**SUBJECT:** COMANCHE PEAK NUCLEAR POWER PLANT, UNITS 3 AND 4  
DOCKET NUMBERS 52-034 AND 52-035  
RESPONSE TO REQUEST FOR ADDITIONAL INFORMATION NO. 5947  
(SECTION 3.7.2)

**RAI NO.: 5947 (CP RAI #226)**

**QUESTION NO.: 03.07.02-23**

**QUESTION NO.: 03.07.02-24**

Figure 10 - Nodes used for UHSRS Base Slab Response Spectra ISRS (Relates to Figures 3KK-3, 1-3)

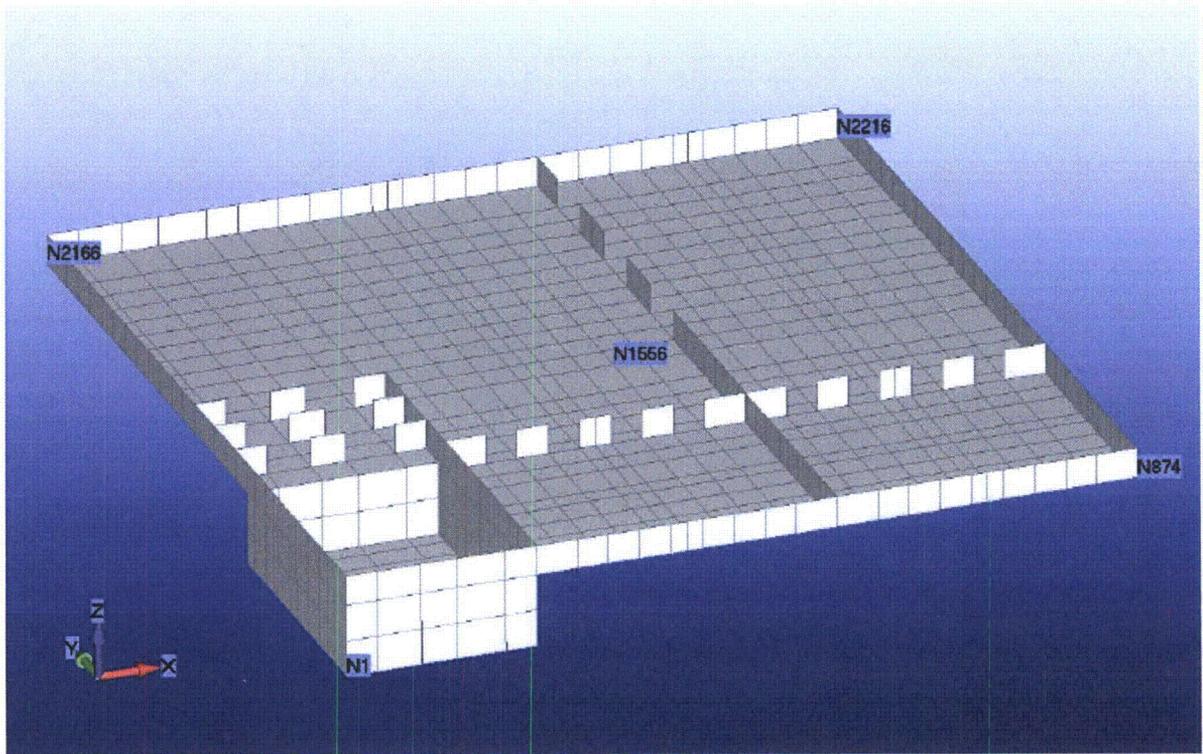
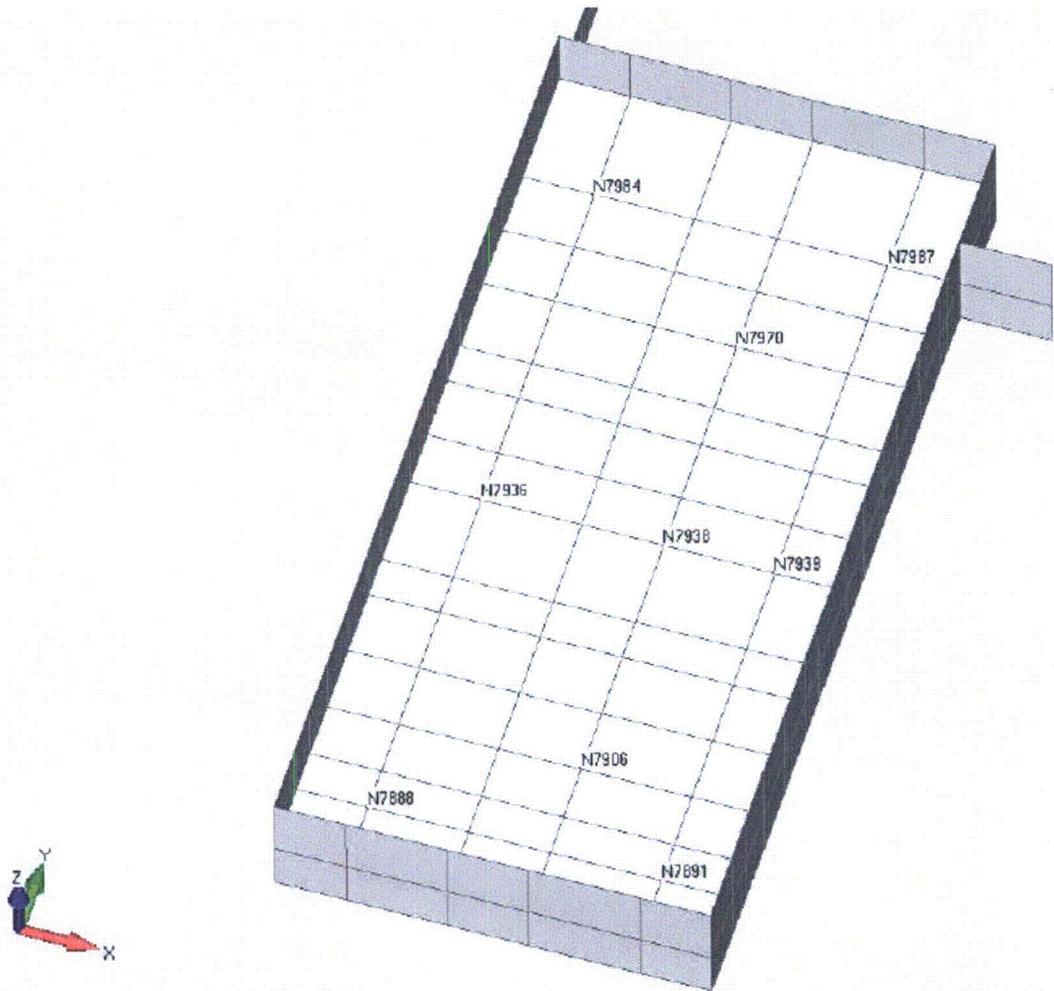
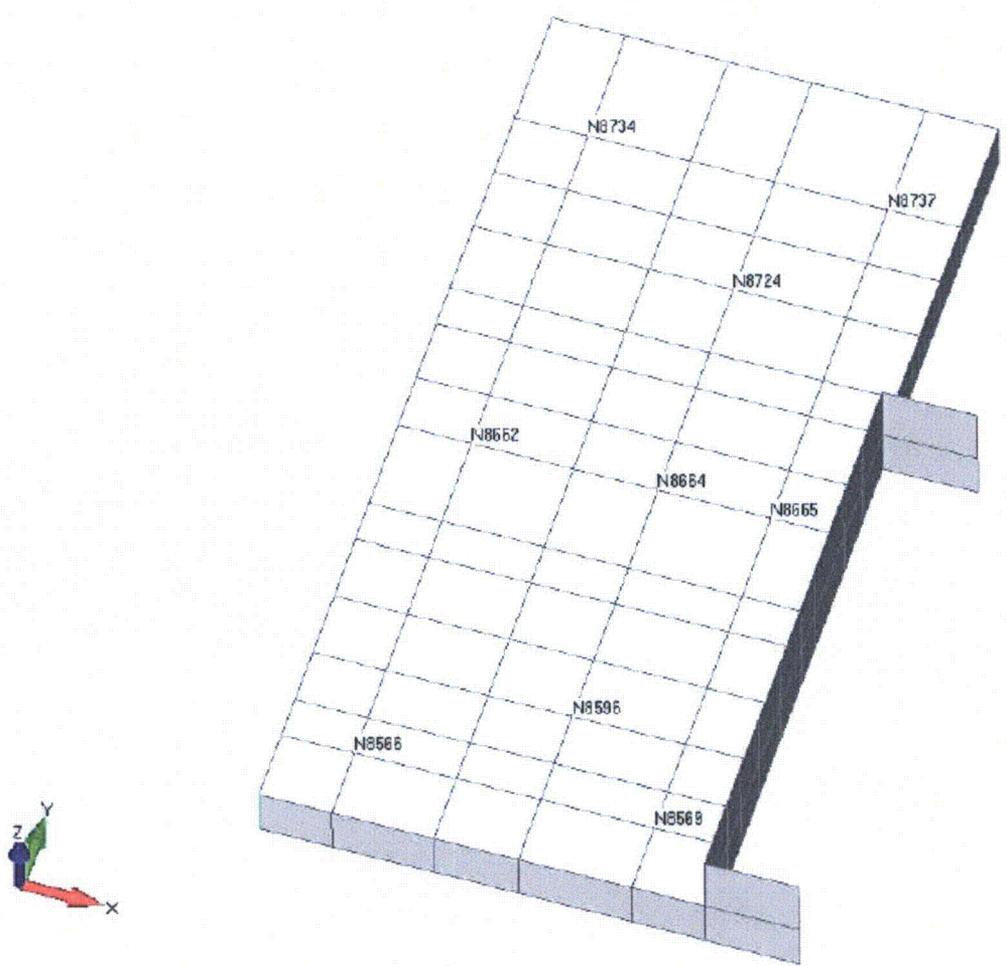
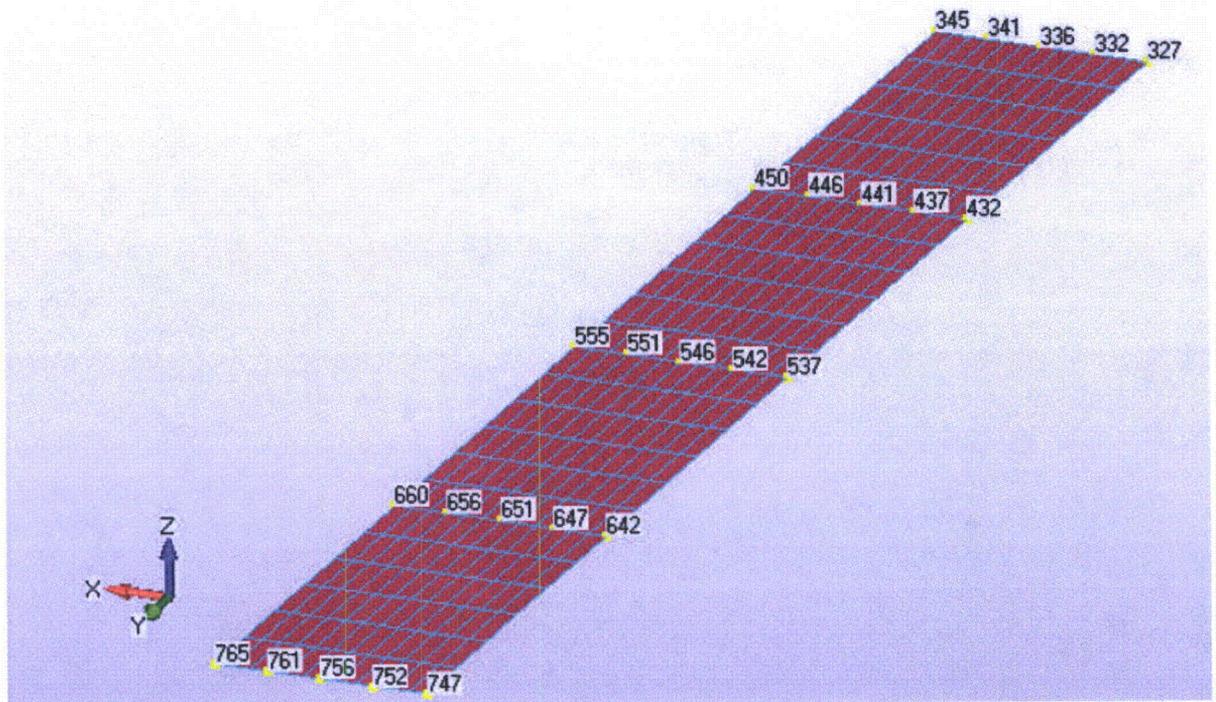
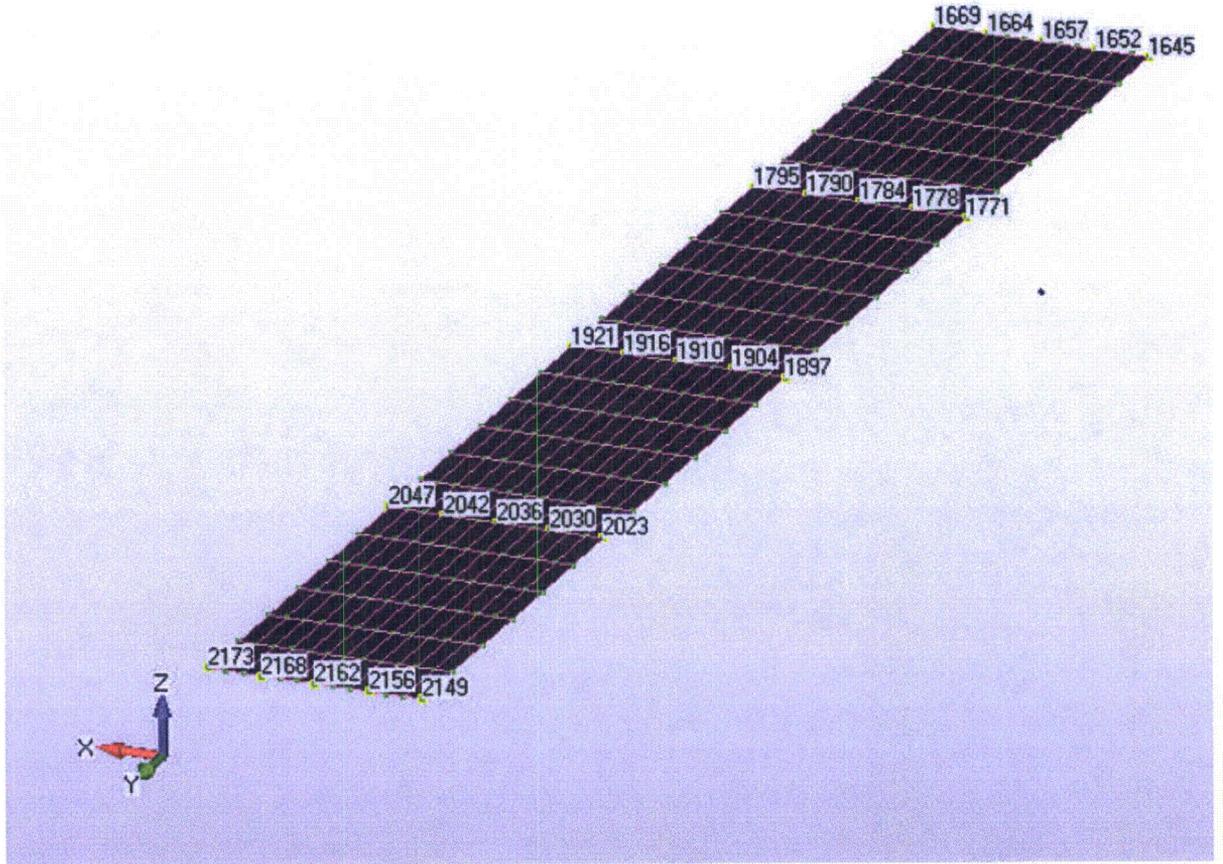
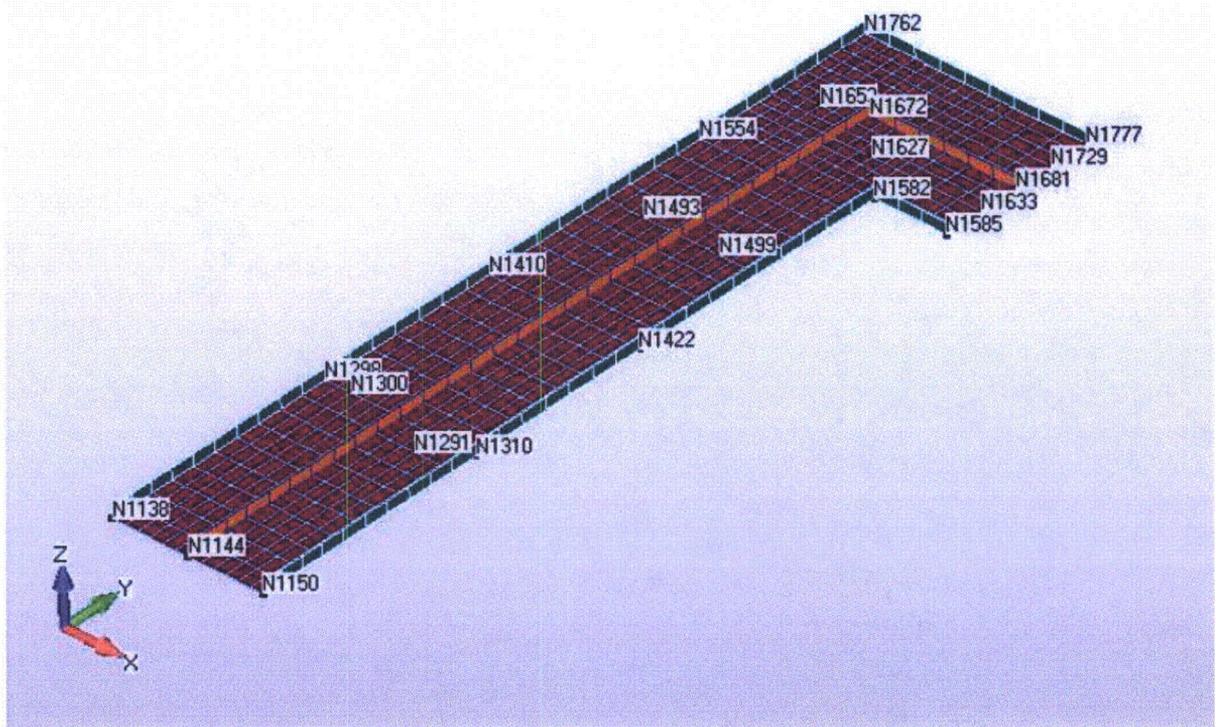
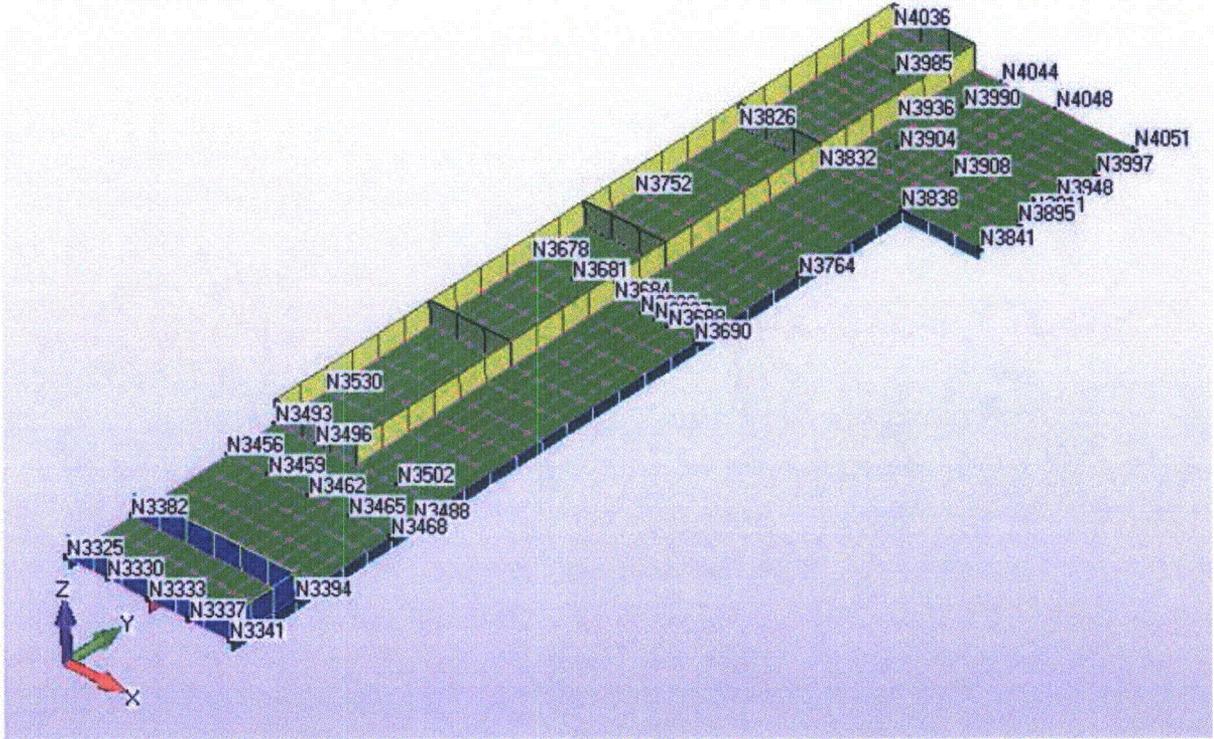
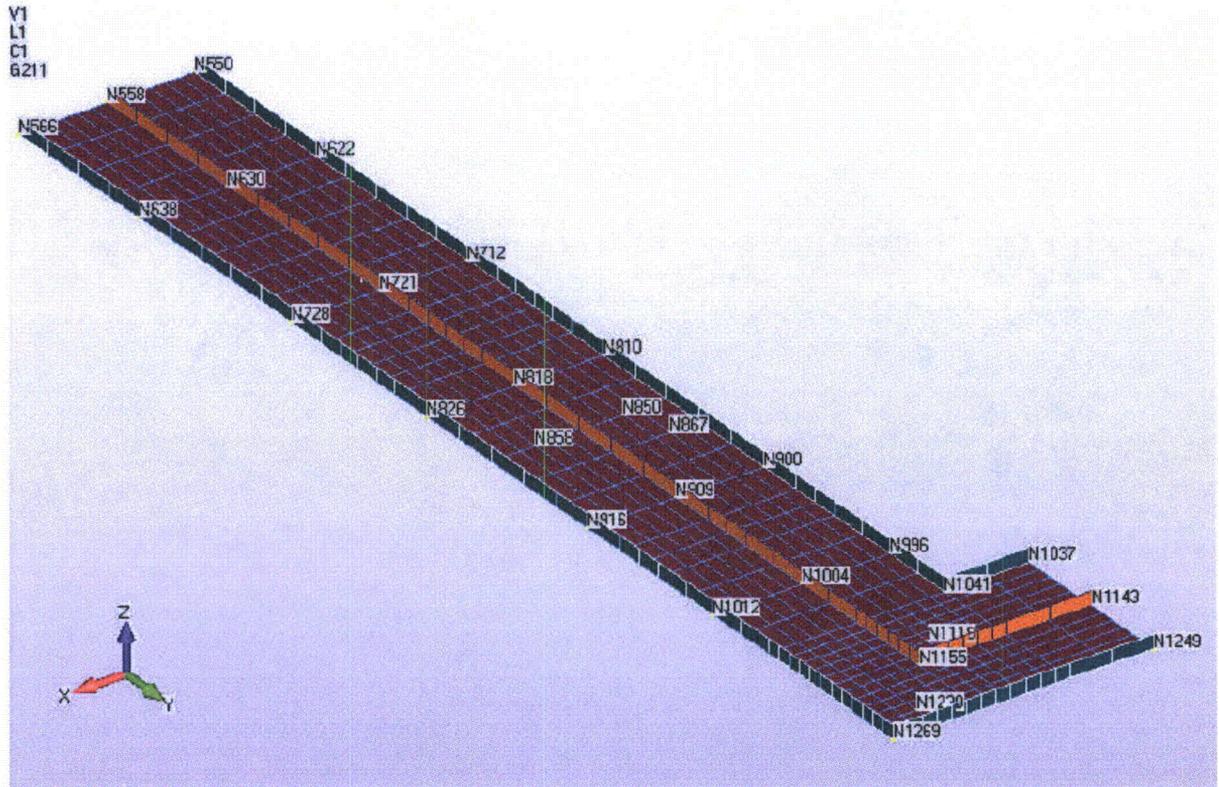
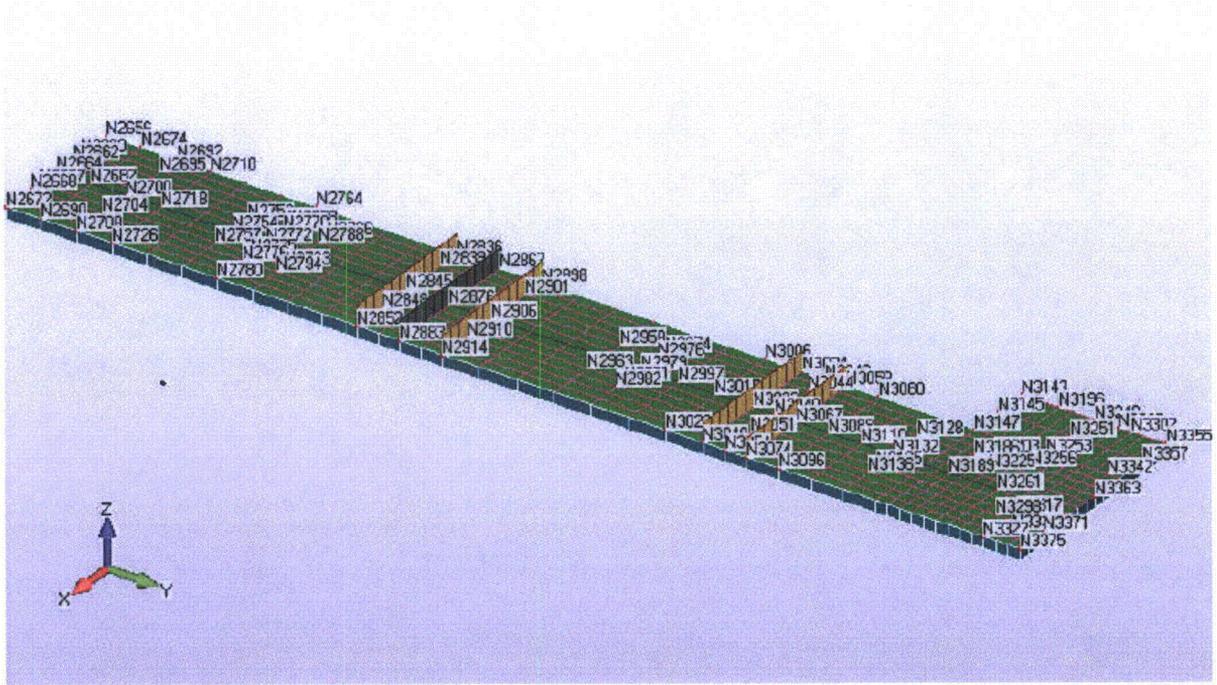
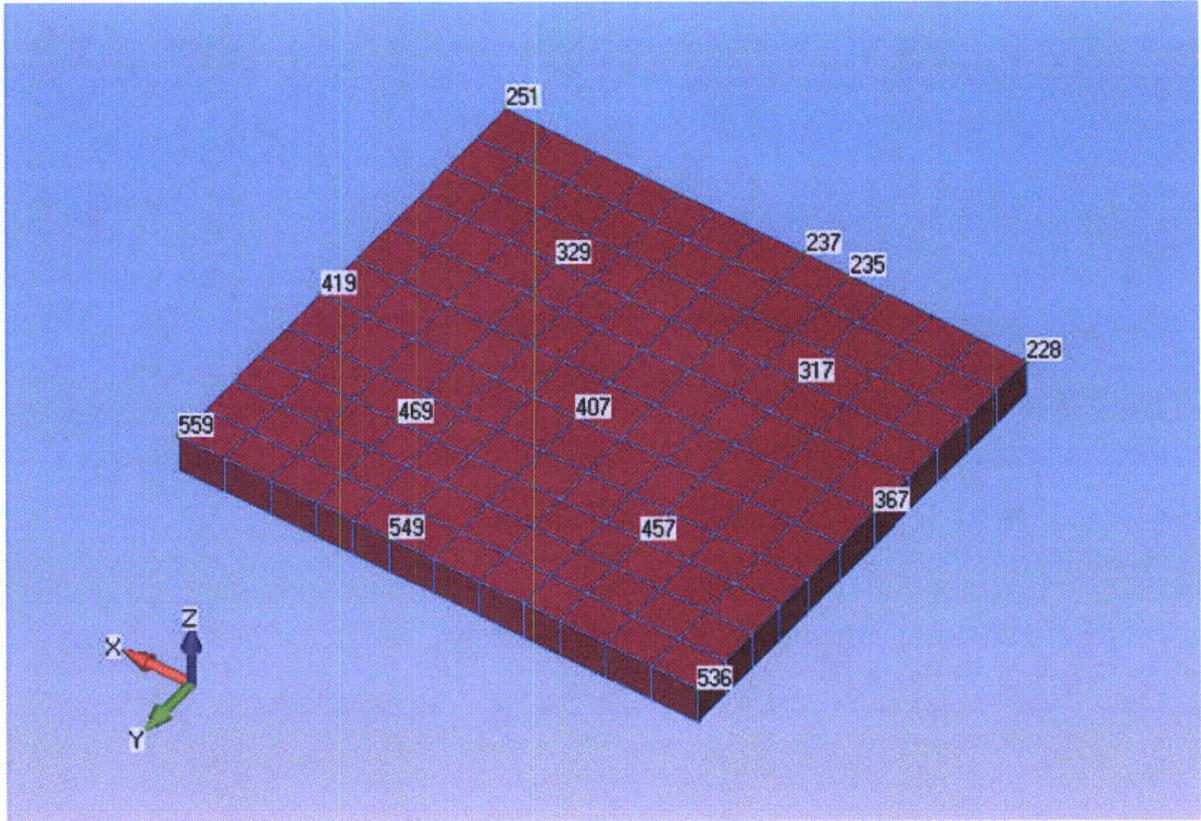
6. The applicant is requested to provide the specific location and node numbers of all nodes used for the generation of ISRS that are shown in Appendices 3KK through 3NN.
